Re: MOE Comments Hidden Quarry

We are pleased to respond to the comments provided by the Ministry of the Environment. We have attached the original MOE comments in Appendix A and have not duplicated the comments in the text of this report.

Hydrogeologic Impact Assessment
 Proposed Aggregate Extraction
 Part of Lot 1, Concession 6
 Township of Guelph/Eramosa, County of Wellington

Figure 1:
Monitoring Locations

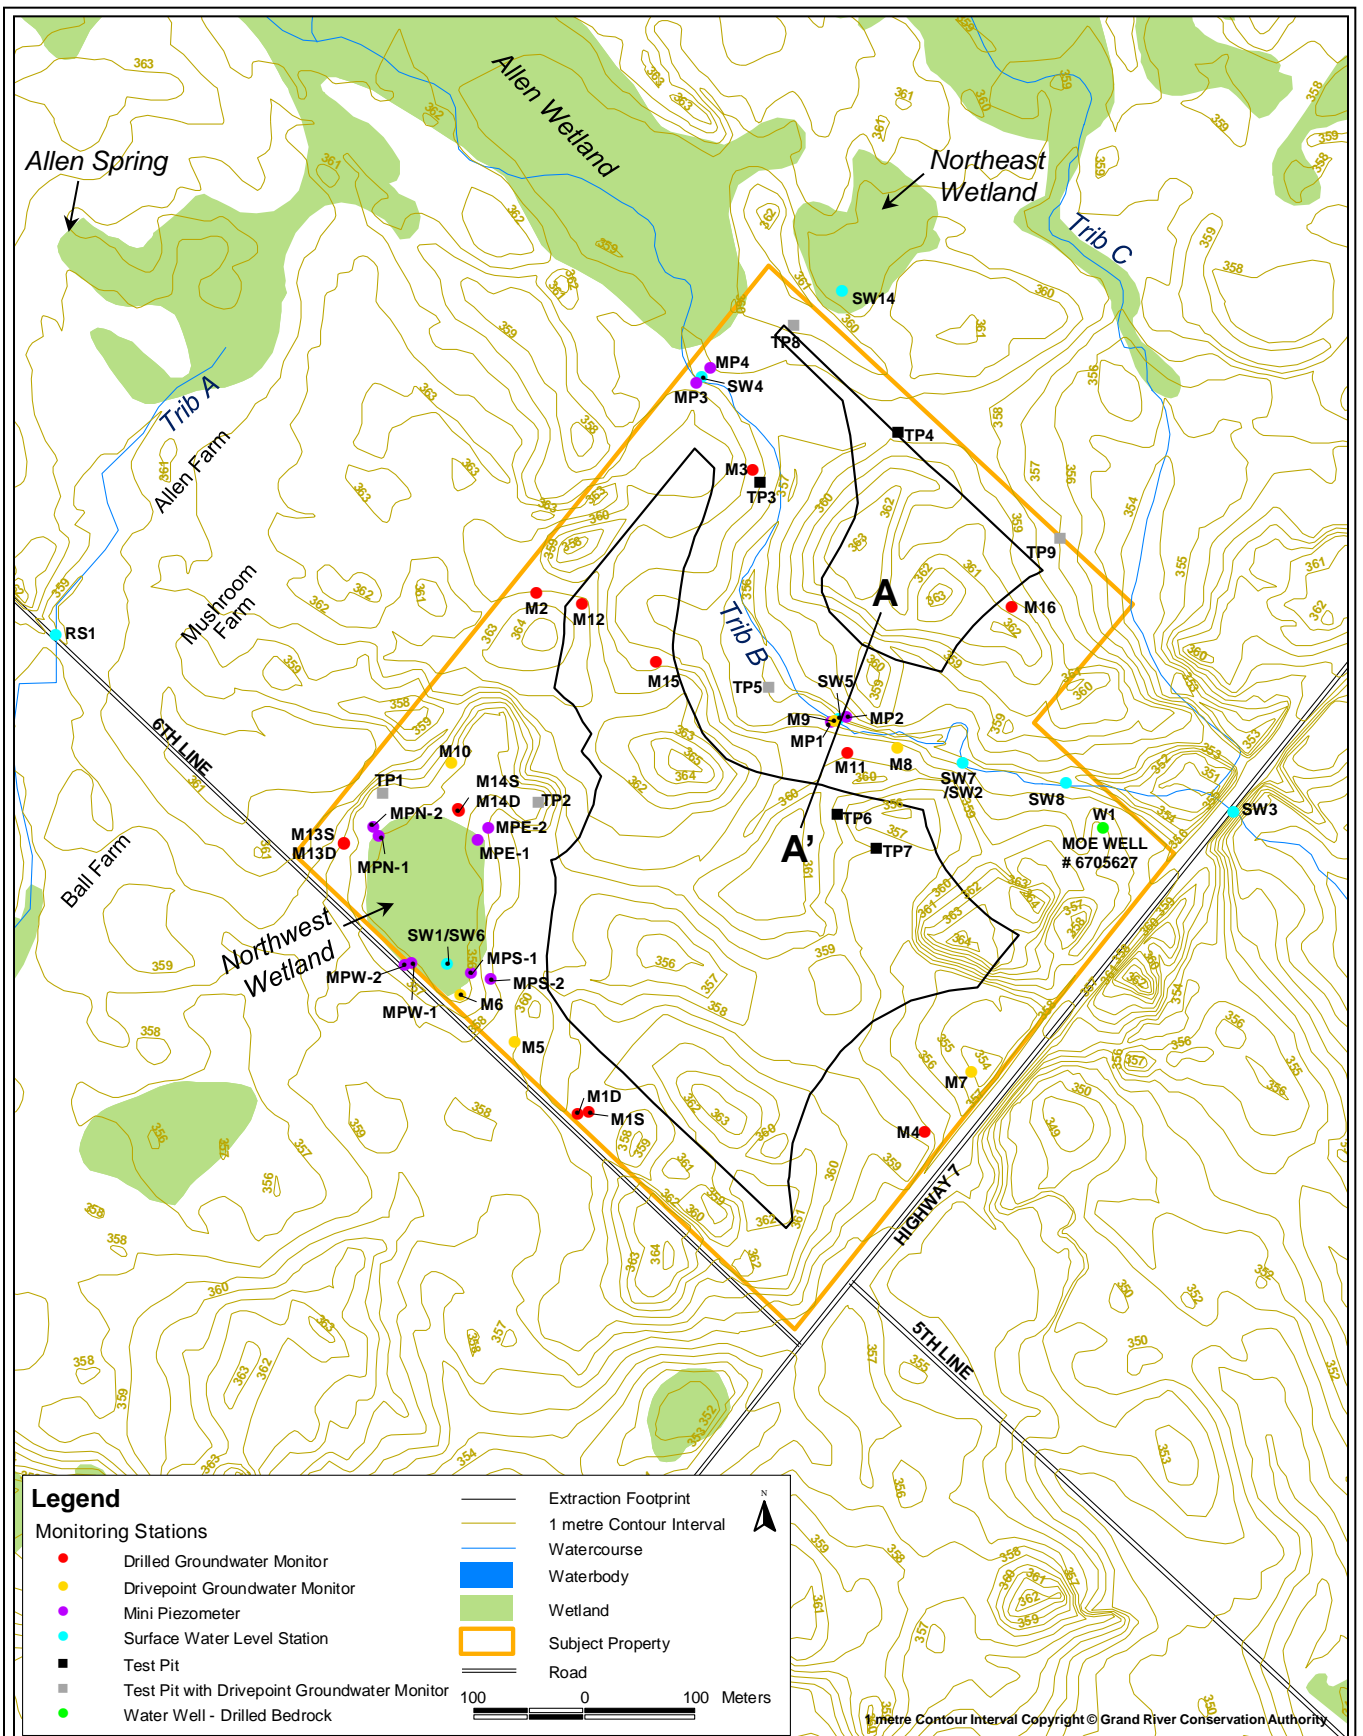
- a. There is a lack of bedrock monitoring points in the area to the east of the stream crossing the Site; thus, at least a monitoring well should be drilled on the area; water levels should be monitored before bedrock extraction begins, and the well should be added to the monitoring plan.

GC5a) In our response to water quality concerns raised by the GRCA, we confirmed that James Dick Construction Ltd. was willing to install groundwater monitors M15 and M16. These locations are shown on Figure 1.

Figure 2: Hydraulic Gradient Analysis

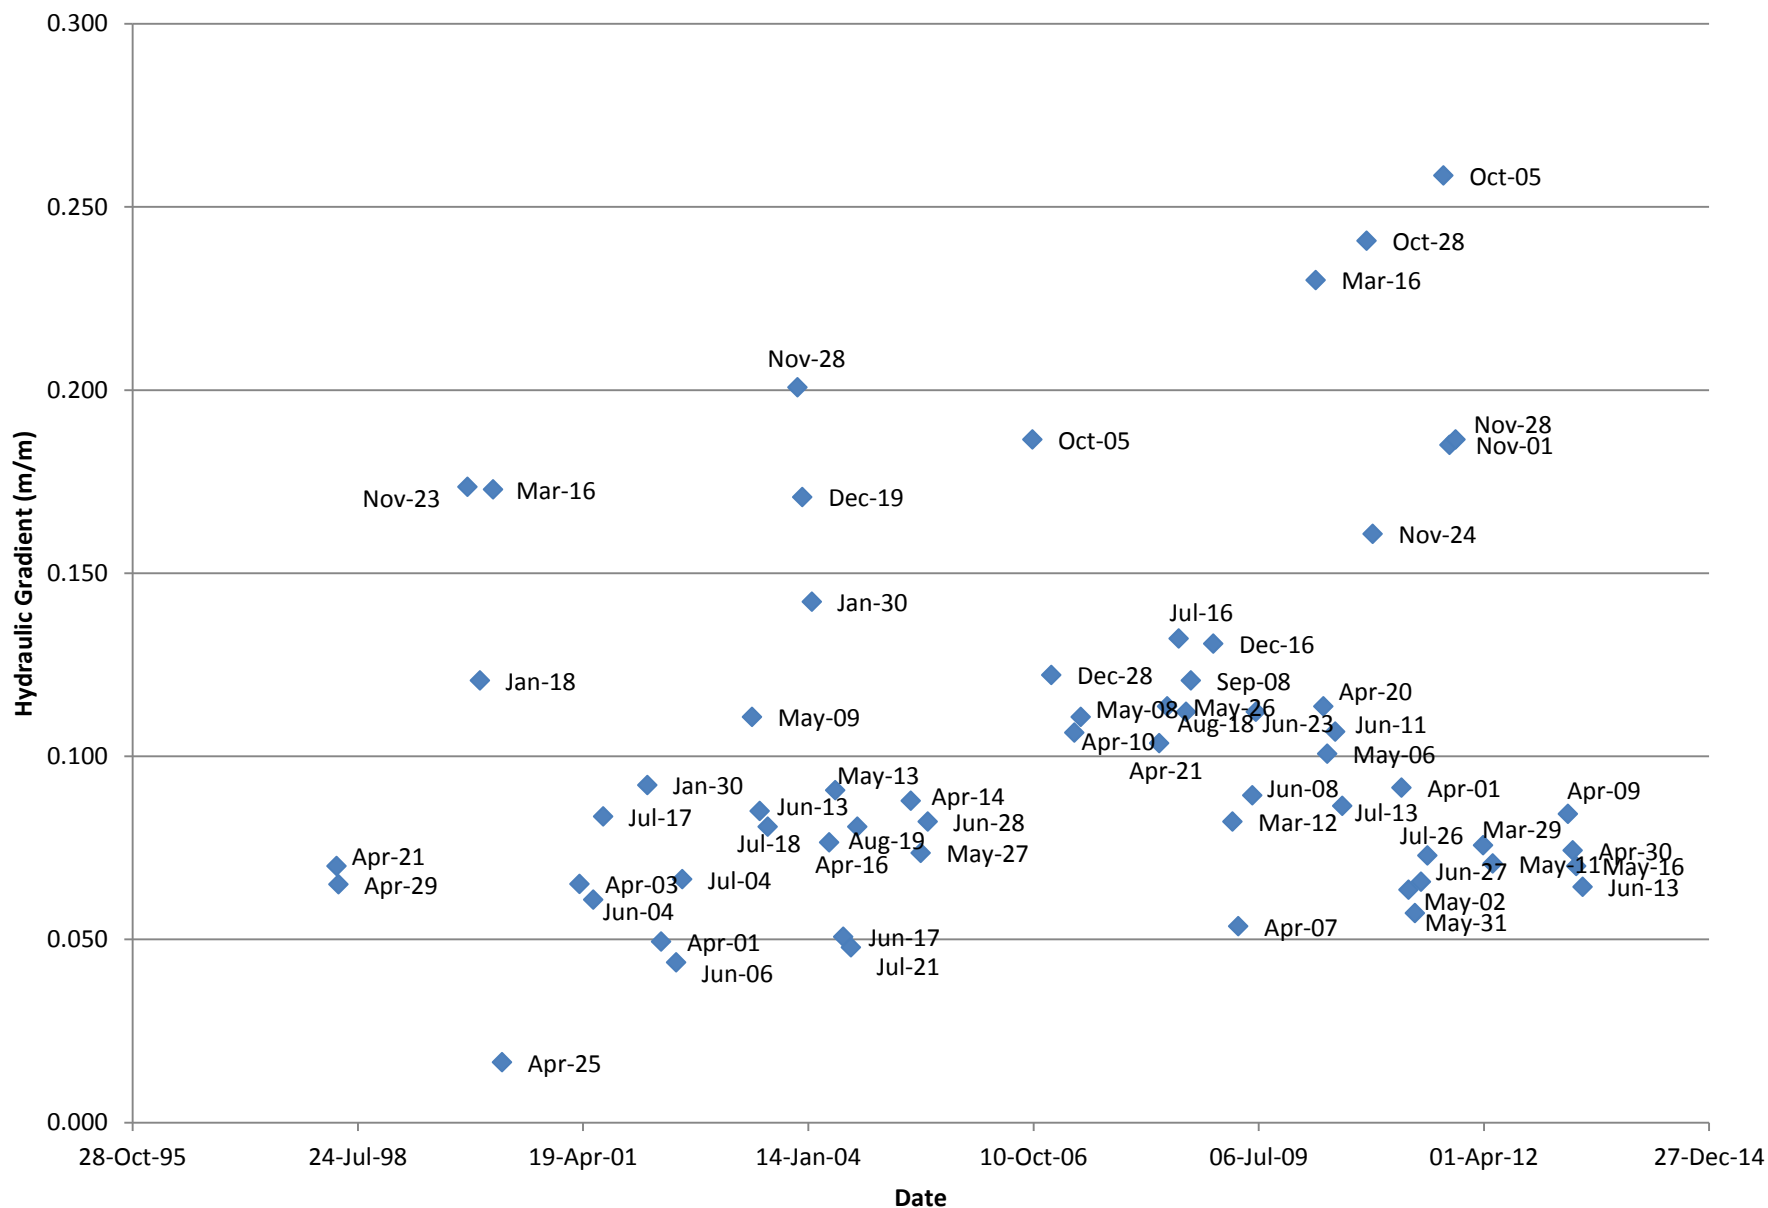
SWC1) Hydraulic Gradient Analysis related to Streamflow Loss in Tributary B

Figure 2 shows a hydraulic gradient analysis between Tributary B monitoring station SW5 and groundwater monitor M9. For the purpose of this analysis we assume that the creek flow is channelized and the distance from the edge of water to groundwater monitor M9 does not change. The hydraulic gradient ranges from 0.016 m/m to 0.259 m/m. The highest gradients are observed in October/November when the sediments beneath the creek are unsaturated. The lowest gradients occur in the spring after the underlying sediments have been saturated for several months.

The data displayed in Figure 2 shows us that where unsaturated conditions occur, the slope of the infiltrating water from Tributary B is approximately 1V:4H. This is a steep slope and considering that the bedrock aquifer is approximately five metres beneath the creek at SW5, the zone of infiltration will not extend beyond a distance of 20 metres from the creek edge. This condition is confirmed at M11 which is located 23 metres from Tributary B. Although hydraulic gradients decrease in magnitude seasonally, standing water has never occurred in M11 indicating that all infiltrating water intersects the water table in the bedrock aquifer within 23 metres of the creek. No layers of significant permeability contrast are revealed in the drilling log of M11 and no isolated layers of saturated soil were encountered in the drilling of M11.

Figure 4: Loss of Streamflow Tributary B

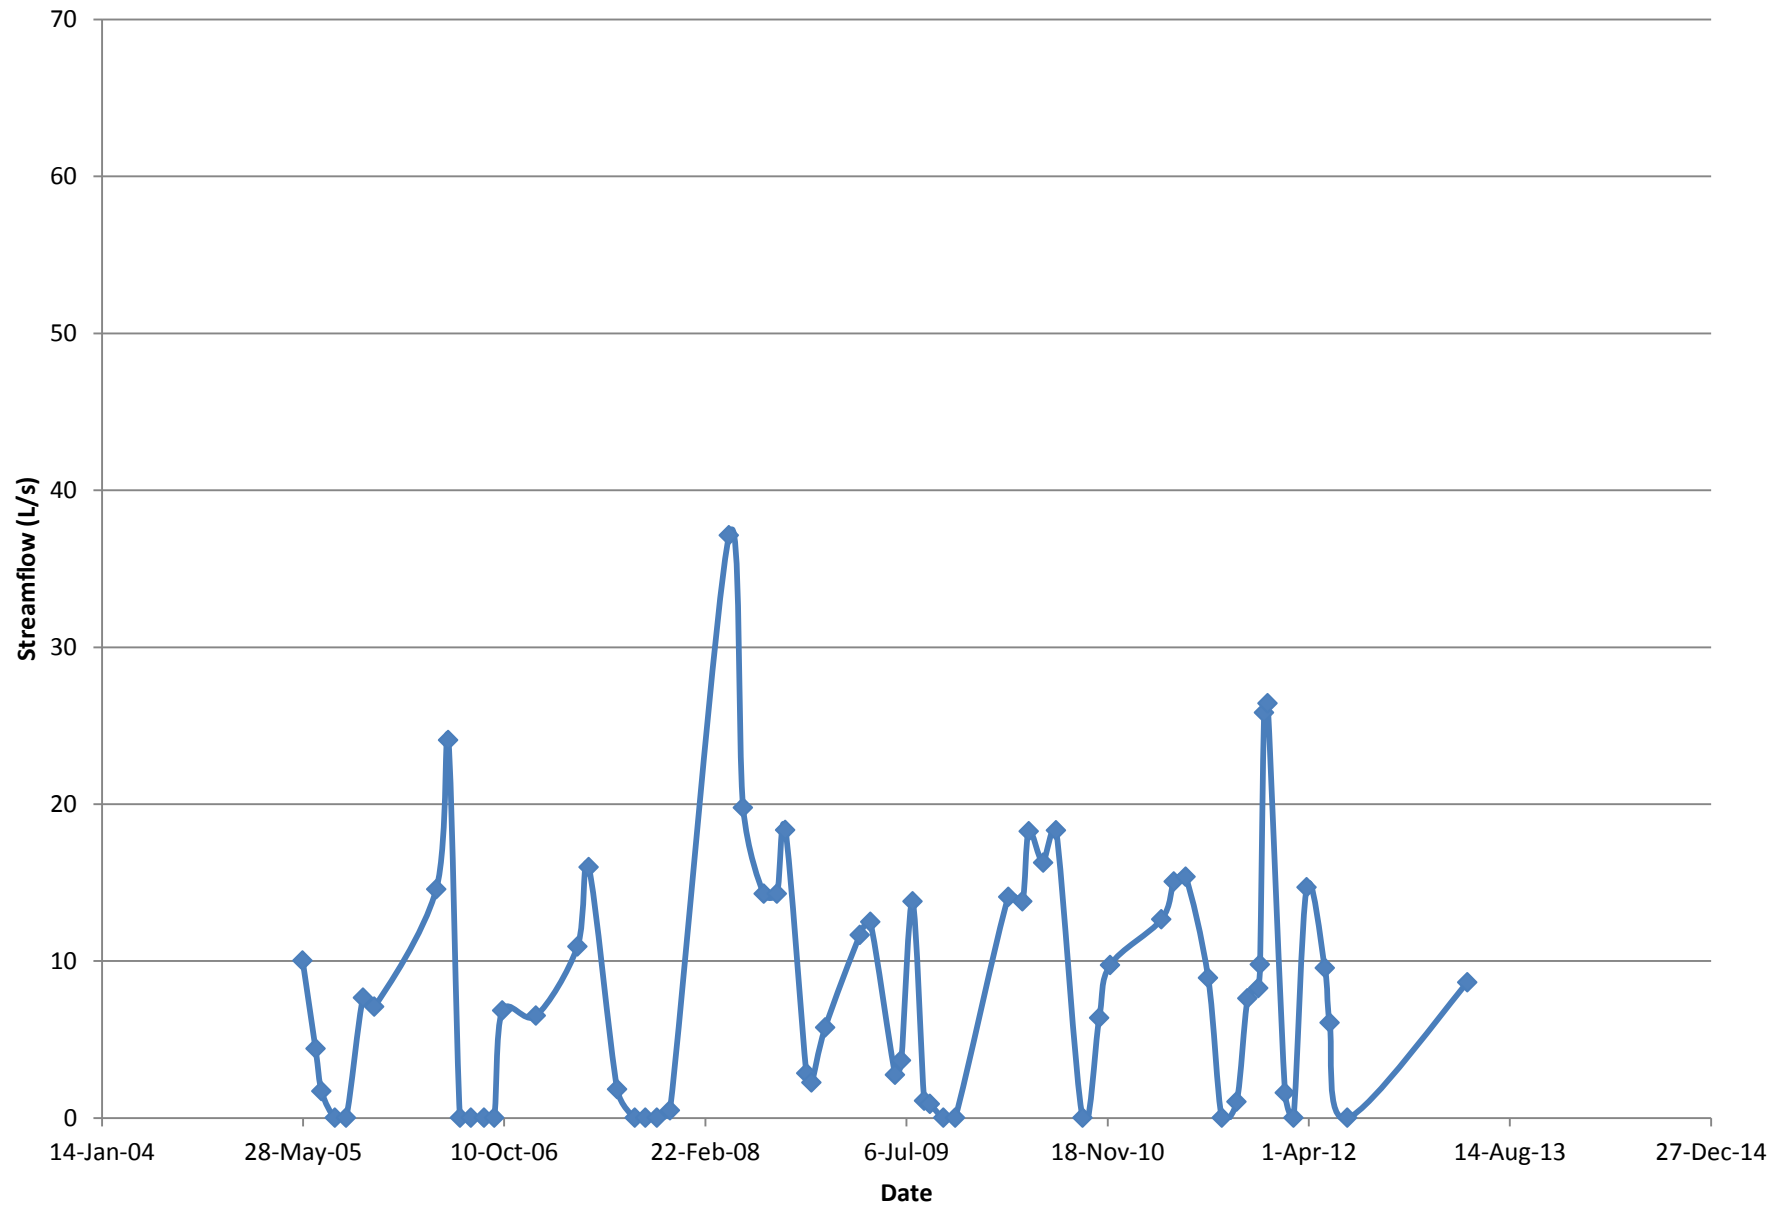
Monitoring of Streamflow Loss from Tributary B

In order to evaluate the loss of streamflow from Tributary B, the flow measured at SW3 will be subtracted from the flow measured at SW4 and compared to historical rates of loss. The rate of streamflow loss is highly variable and decreases to zero during the summer months. Figure 4 is a summary of monthly streamflow loss from Tributary B across the site. Included in the annual report will be an analysis of the streamflow loss and a continuation of this graph (between stations SW3 and SW4). If anomalous streamflow loss occurs, the cause will be evaluated and contingency measures invoked. Groundwater levels are more accurate than streamflow measurements and monitors MP1, MP2, MP3 and MP4 have been added to the groundwater monitoring program. An interpretation of results will be presented in the annual monitoring program and the results will be evaluated for anomalous or trending data. Should a change in streamflow loss or water level (in MP1-MP4) be noted, contingency measures as presented in Appendix C will be initiated.

Figure R2:
Monthly Precipitation Comparison with Stream Flow

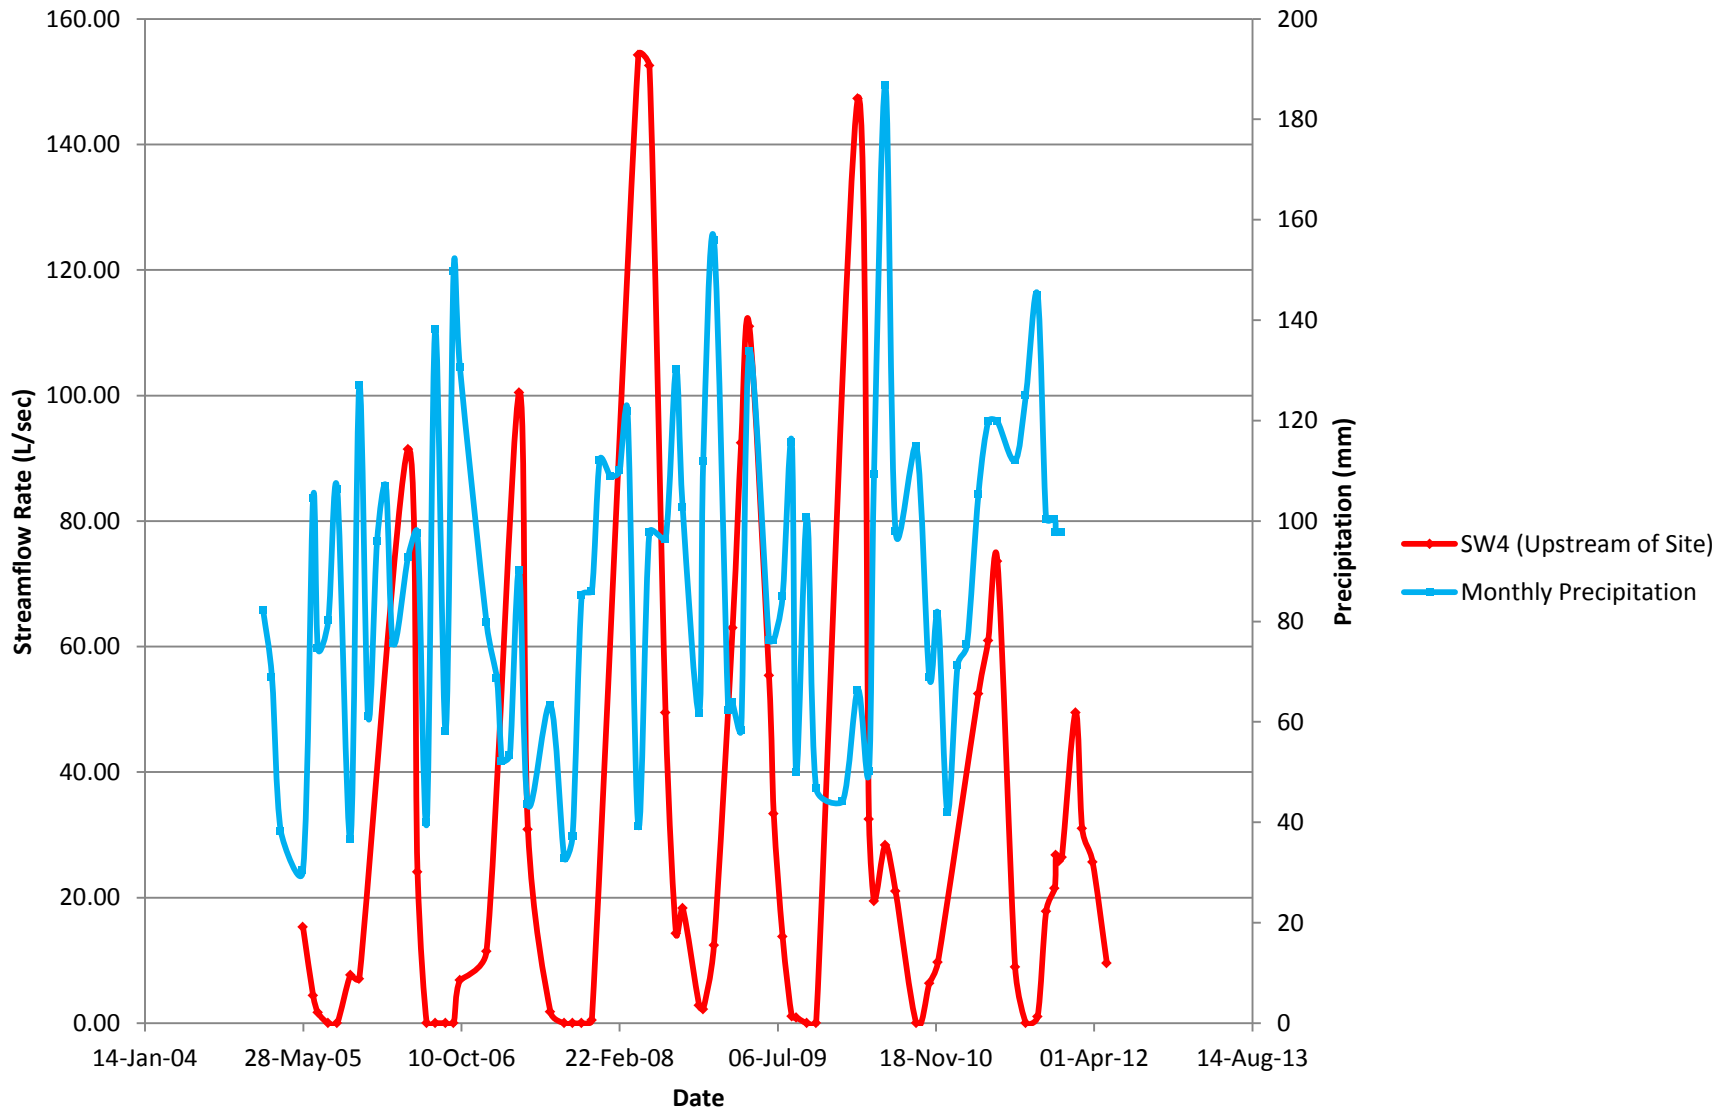
SWC4) Detailed analysis of Streamflow in Tributary B and water levels in Northwest Wetland

Figures R2 and R3 were submitted to Burnside and Associates in response to a similar question of the relationship between precipitation and flow in Tributary B. Figure R2 compares monthly precipitation from the Shand Dam in Fergus to streamflow at SW4. The monthly precipitation data does not have an annual pattern whereas flow in Tributary B has a pattern of no flow in the late summer months, increasing flow in the fall, winter, early spring and declining flow in the late spring/early summer months. The magnitude of flow in Tributary B is not responding to monthly precipitation.
